ENGINEERING CLARIFICATION

EC TITLE: Facility 310 REC Piping Adjustments
PROJECT: 3 Kings Water Treatment Plant

EC NO.: 103
DATE: 4/20/2021
STATUS: Open

DRAWING NO.: 310-D-2002 PROCESS MECHANICAL -
FACILITY 300 - AREA 310 - BACKWASH WASTE AND
CLARIFICATION EQUALIZATION ENLARGED PLAN

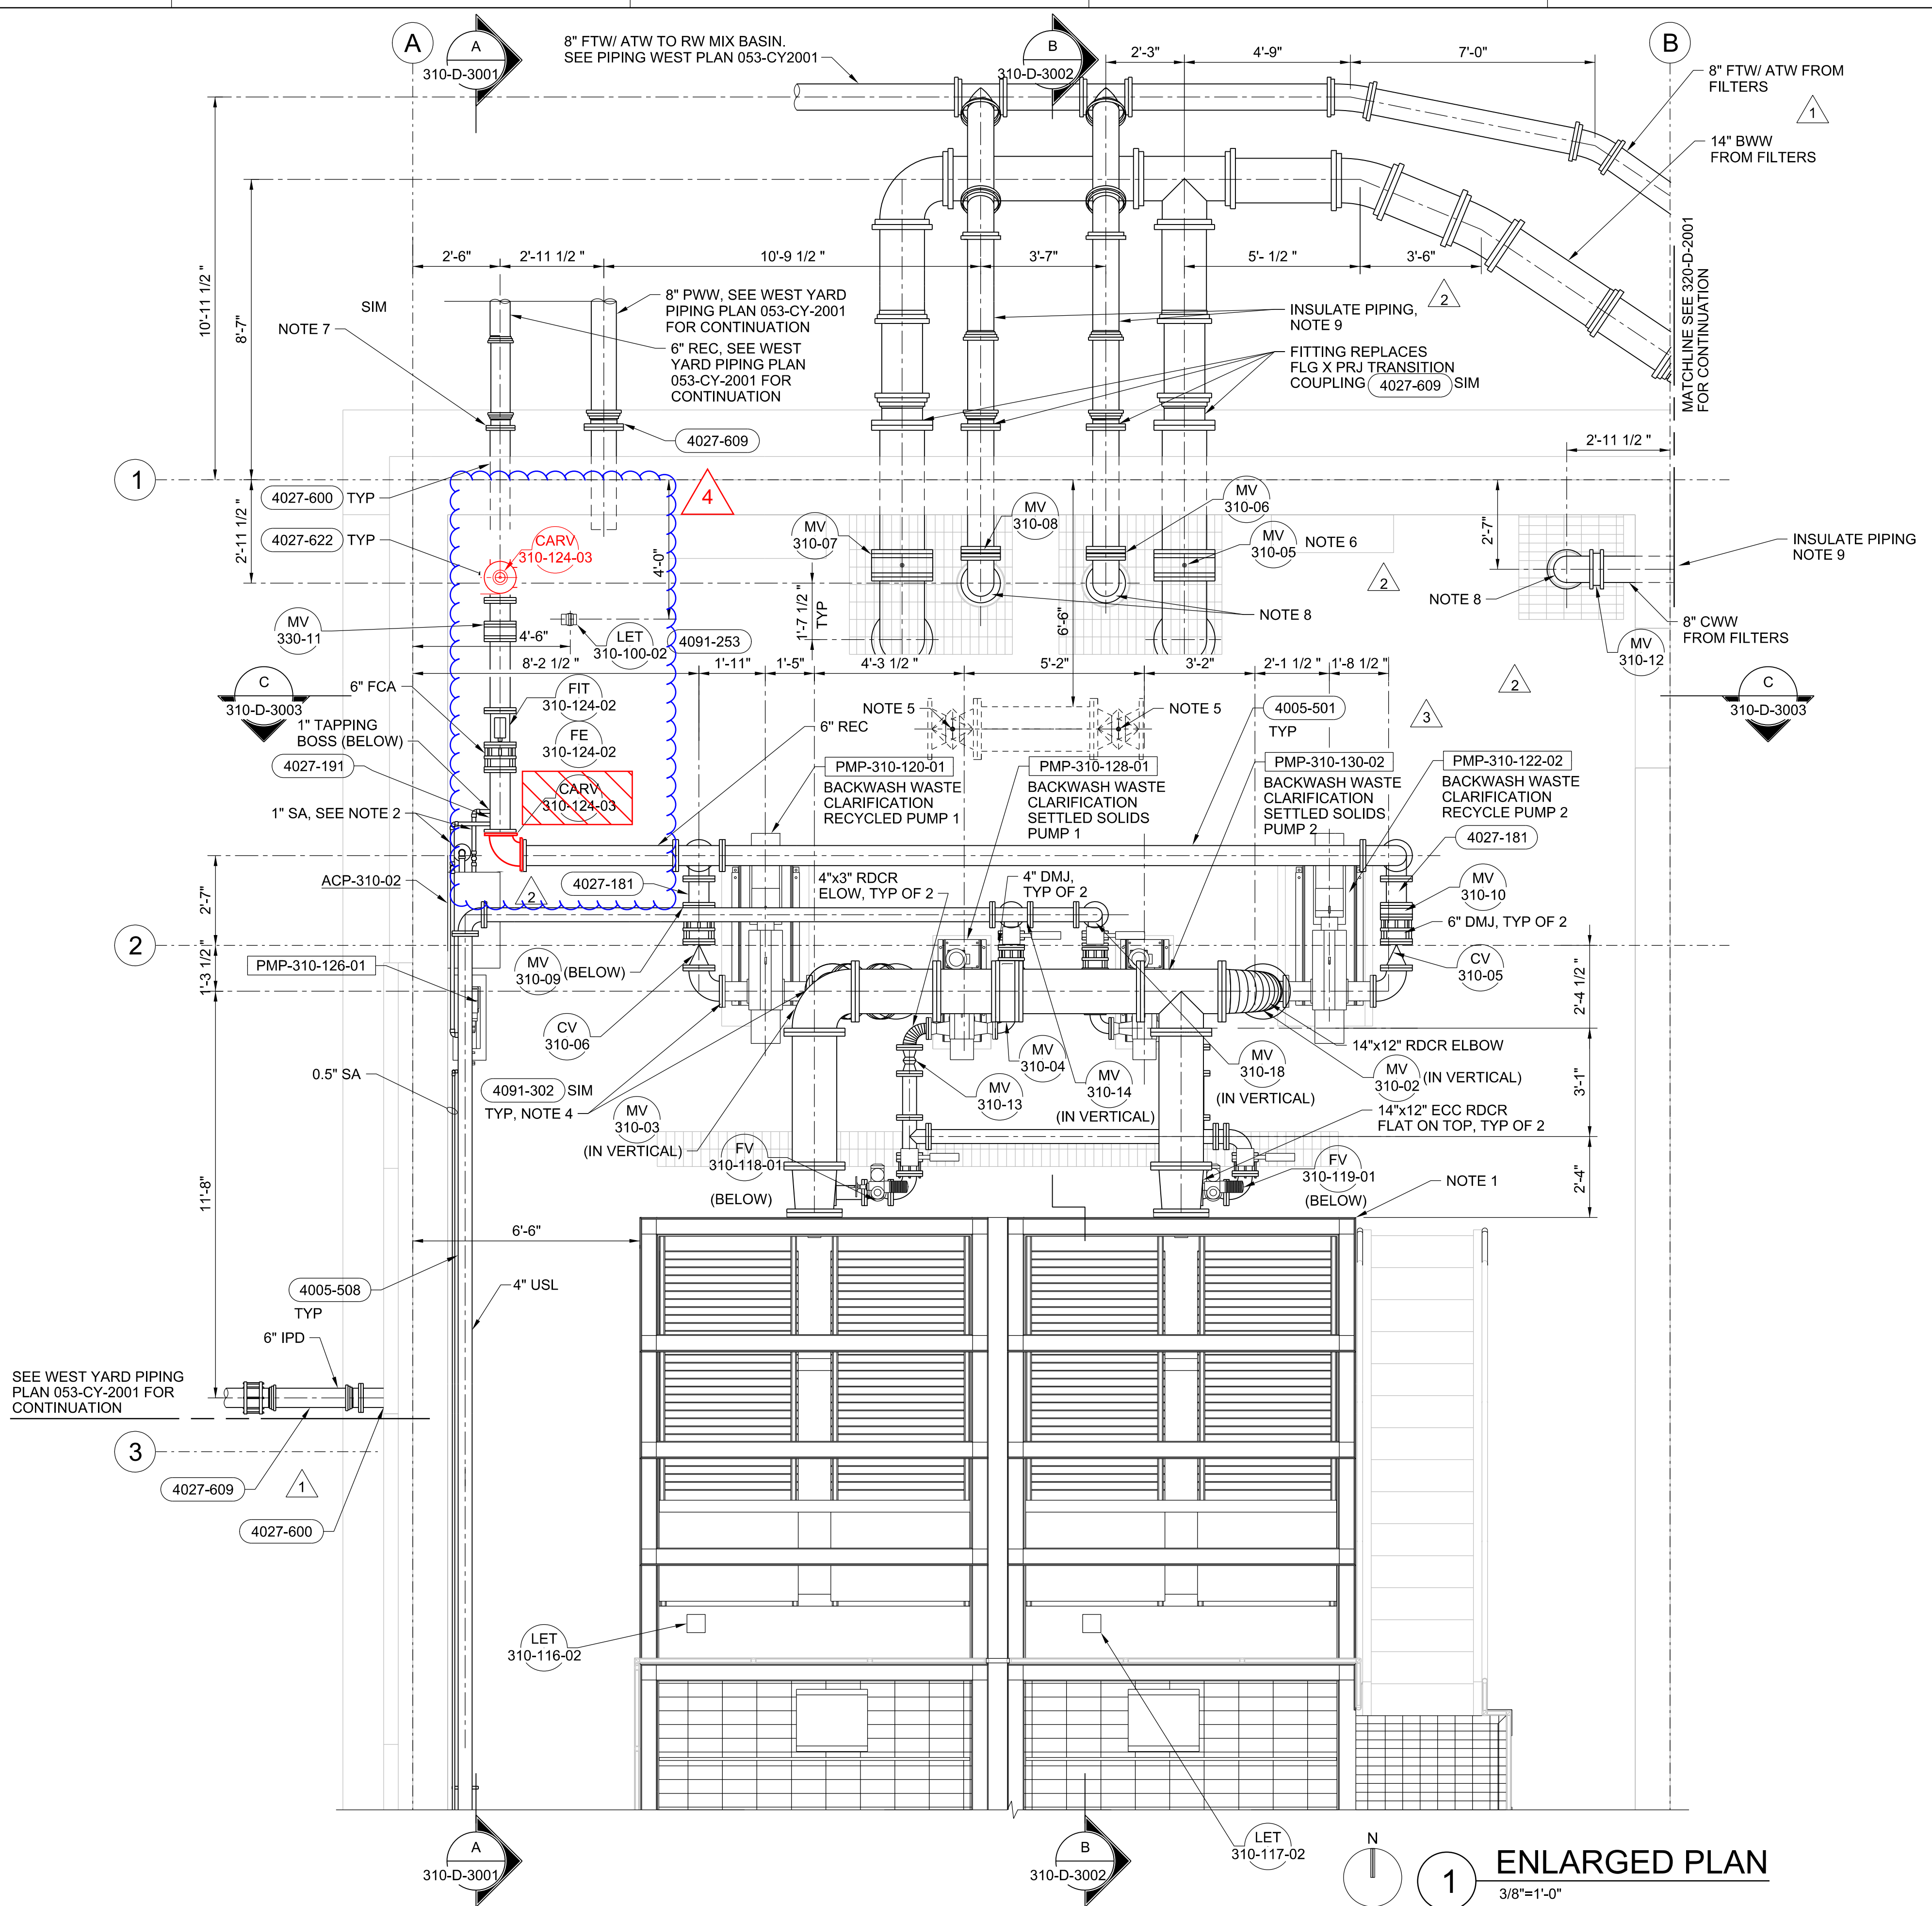
This EC provides adjustments to the REC piping in Facility 310 in response to RFI 175. This RFI requests the piping be moved higher in order to create wall space for the VFD enclosure.

See attached drawing revisions.
